Access Compliance Report

Public Rights-of-Way

(Curb Ramps)

Intersection ID: 27857	Main Street: JOCKEY'S RIDGE DR	Cross Street: WAIGHTSTILL_WY	Location: SE
ADA ID: 863993792D73	Ramp Type: BlendTrans2	Initial Pass/Fail: Fail	Overall Compliance: No
Severity Score: 1.25			
Codes/Mitigation Info/Possible Solution		Field Measurements/Component Compliance

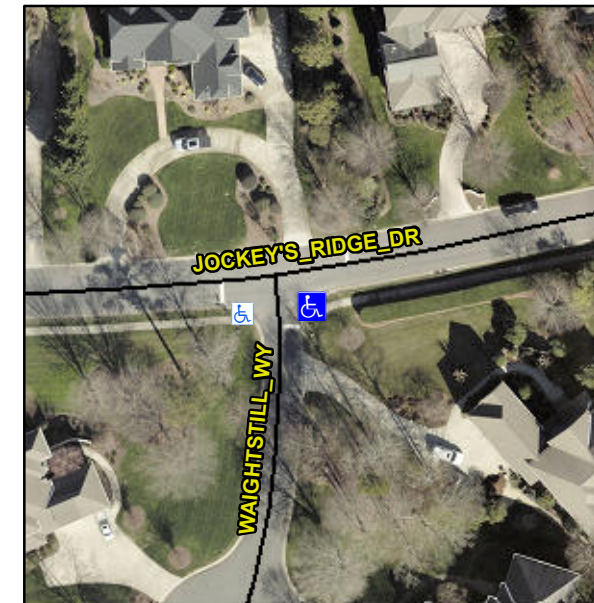
PROW/ADA:

Not Found, R304.5.3

Remove & Replace Curb Ramp With Two New Directional Ramps or Equivalent.
